Planning Board Work Session & Meeting Thursday November 5, 2026

- a. **PB 2026-12: 44 Regina Ave | Cortlandt Self-Storage & Contractor's Storage Area**
Application of Cronin Engineering on behalf of Cortlandt Self-Storage LP / Mark Giordano for an Amended Site Development Plan to construct one additional 10,400SF storage building and legalize an outdoor contractor's storage area. Drawings last revised September 23, 2026. (see prior PB 11-96, PB 30-99, PB 3-06, PB 2021-17)

**Re: Amended Site Plan Application
Cortlandt Self Storage, L.P.
44 Regina Avenue
Town of Cortlandt, New York
Tax Map Designation: 24.10-1-4**

This submission addresses the comments made at the October 6, 2026 Planning Board Work Session and Meeting. Annotated responses to those comments are provided below:

SITE DEVELOPMENT PLAN

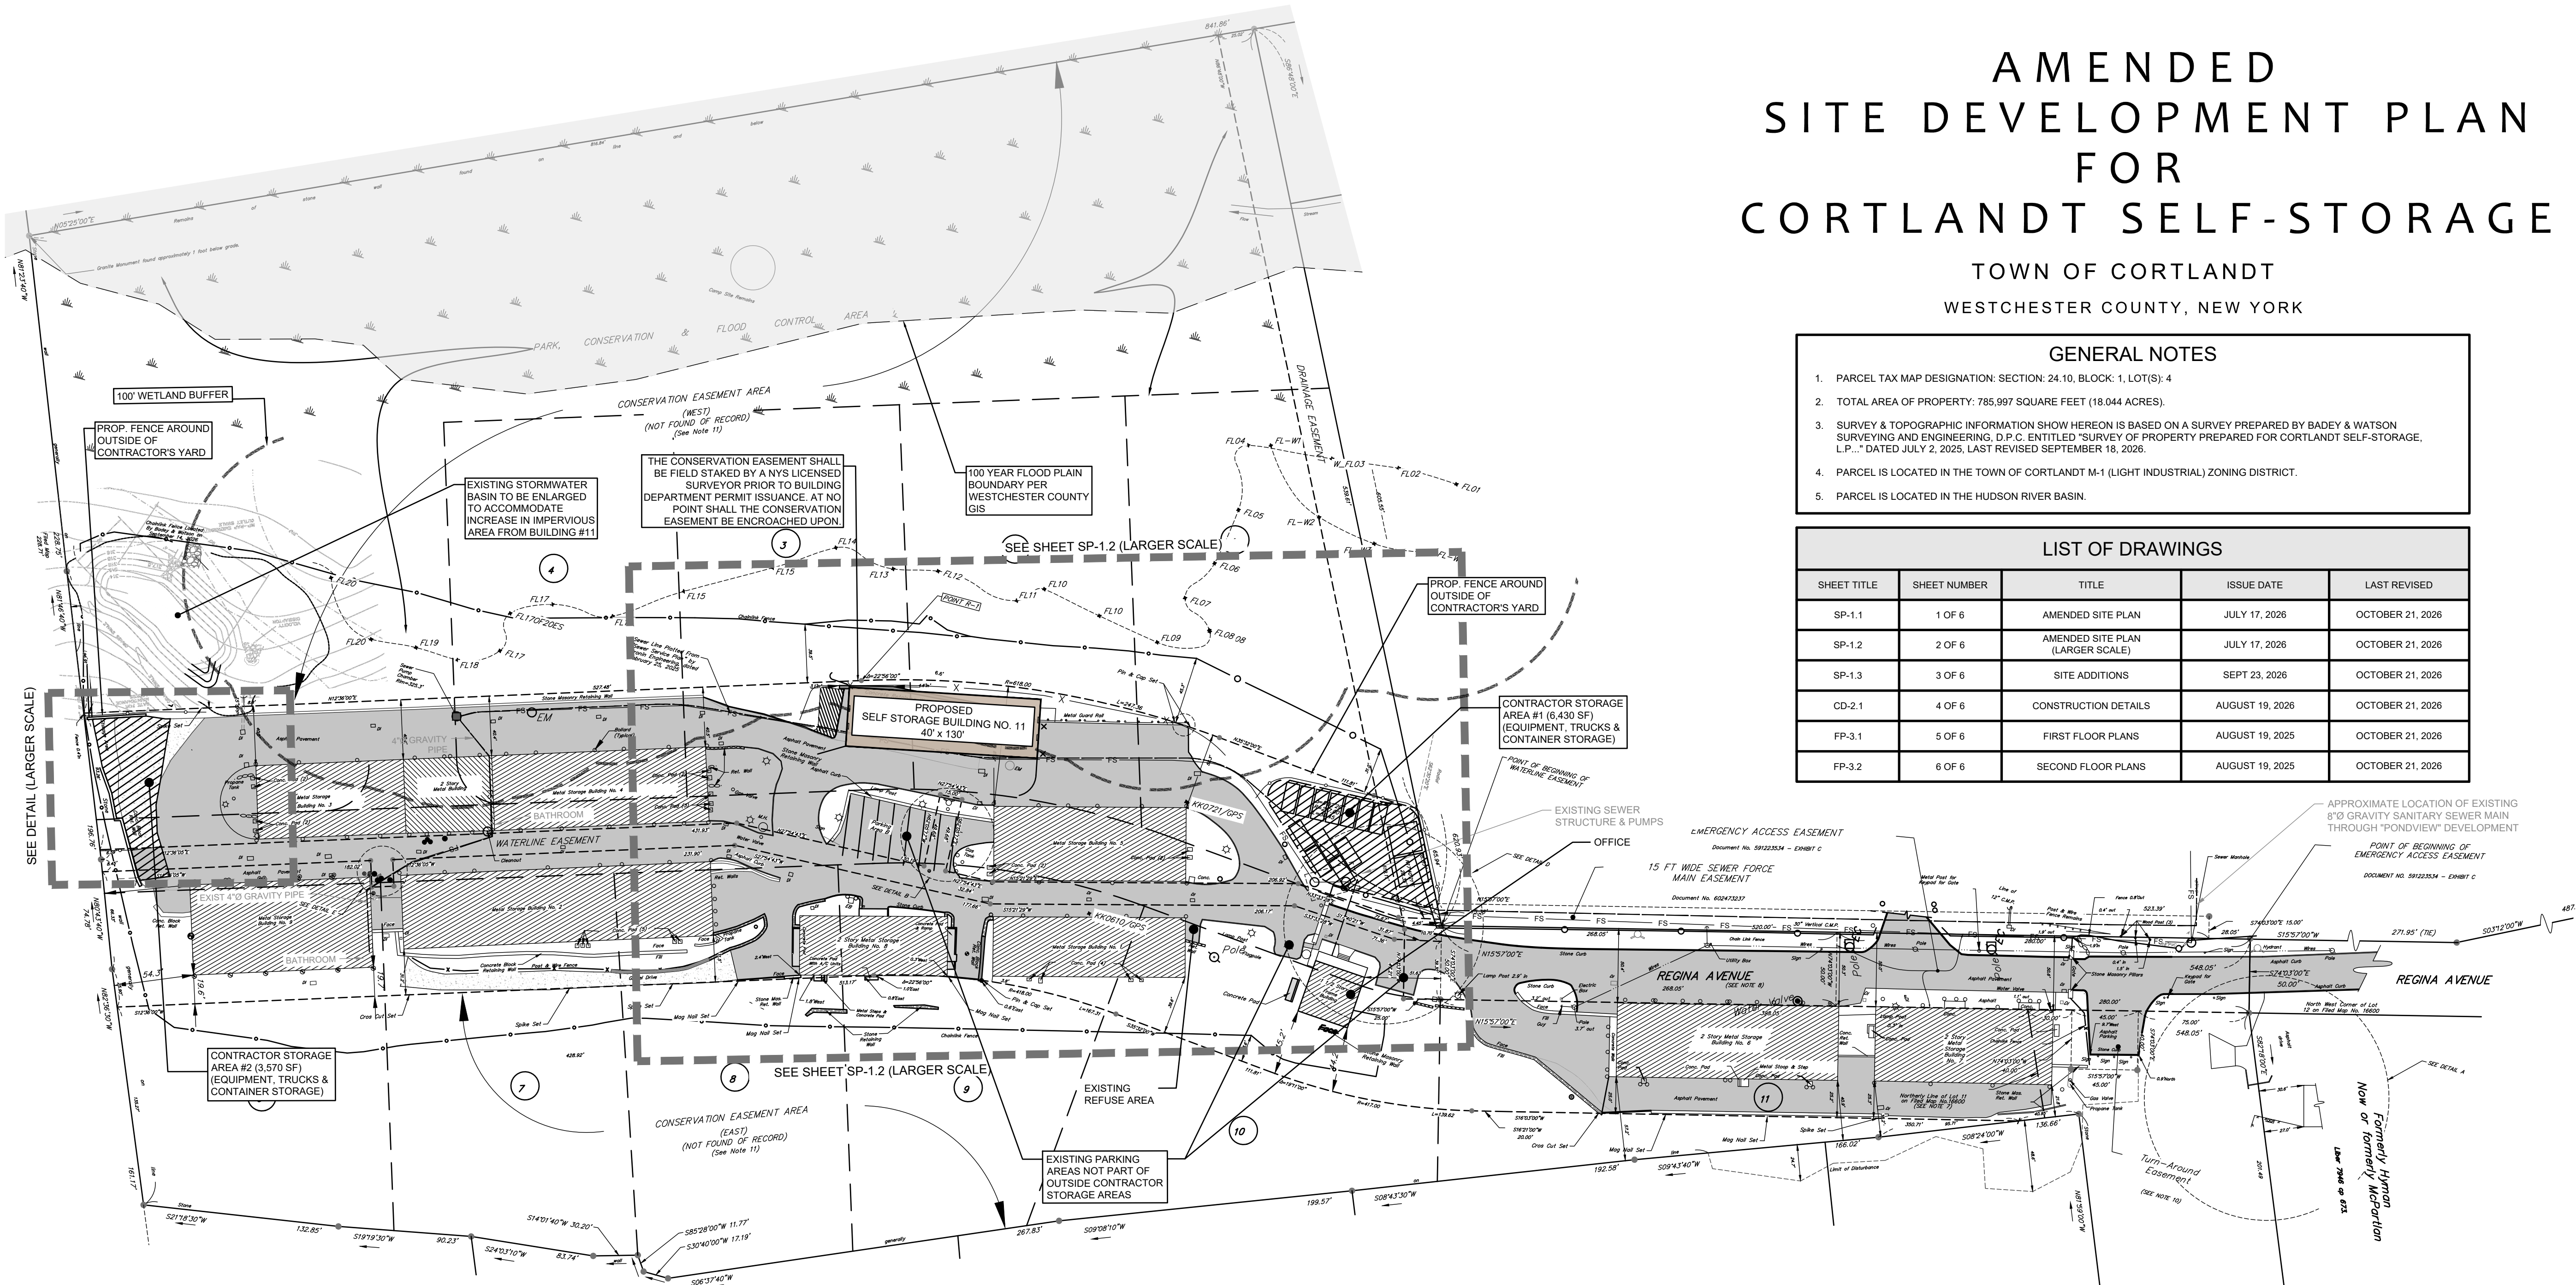
1. **Total Contractor's Yard Area.** *Contractor's yard use is limited to an area of 10,000 sq. ft., which is the total currently shown on the plan. If we are expanding the contractor's yard area in any location, it will need to be reduced elsewhere on the site to maintain compliance. Need to show dimensions on the plans (comment from site visit)*

2. **South Contractor's Yard.** *Since the area expanding beyond the gravel area, need to mark the location both on the plan and on the site (with paint). Extend the fencing between Building 9 and Contractor Storage.*

3. **Drainage.** *Show elevation grade/pitch on plan that will ensure that stormwater will drain toward the internal stormwater drainage system.*

4. **RV/Boat Storage.** *Show spaces for RV and Boat Storage on the plan.*

Response: The Limits of the Contractor's Yard has been modified based on discussion at the Site Visit. The Total area of the Contractor's Yard is 10,000 Square Feet.

Response: The Limits of the South Contractor's Yard on the plan has been updated to reflect areas beyond the gravel area. The limits will be delineated in the field with white striping.

Response: Indication of direction of pitch has been added to the plan.

Response: Spaces for RV and Boat Storage have been shown on the plan between the North Contractor's Yard and proposed Self Storage Building No. 11.
